Well Name: AXI APACHE F	Well Location: T23N / R5W / SEC 13 / SESE /	County or Parish/State: RIO ARRIBA / NM
Well Number: 2	Type of Well: CONVENTIONAL GAS WELL	Allottee or Tribe Name: JICARILLA APACHE
Lease Number: JIC78	Unit or CA Name:	Unit or CA Number:
US Well Number: 3003905055	Well Status: Gas Well Shut In	Operator: DJR OPERATING LLC

Notice of Intent

Type of Submission: Notice of Intent	Type of Action: Plug and Abandonment
Date Sundry Submitted: 02/07/2022	Time Sundry Submitted: 08:33
Date proposed operation will begin: 02/07/2022

Plug and Abandonment Procedure
for
DJR Operating, LLC
AXI Apache F 2
API # 30-039-05055
SE/SE, Unit P, Sec. 13, T23N, R5W
Rio Arriba County, NM

DJR Operating, LLC
Proposed Wellbore Diagram

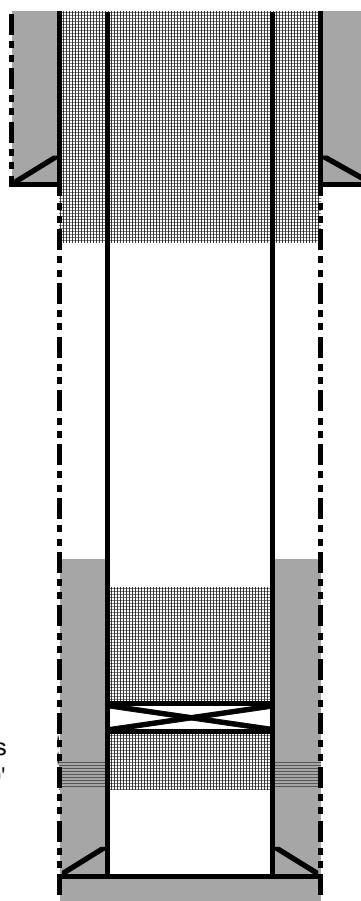
You are also required to place cement excesses per 4.2 and 4.4 of the attached General Requirements.

- The plugs proposed in the P&A procedure will adequately protect any freshwater sands in this well bore.
- Pictured Cliffs perms 2270' – 2290'.
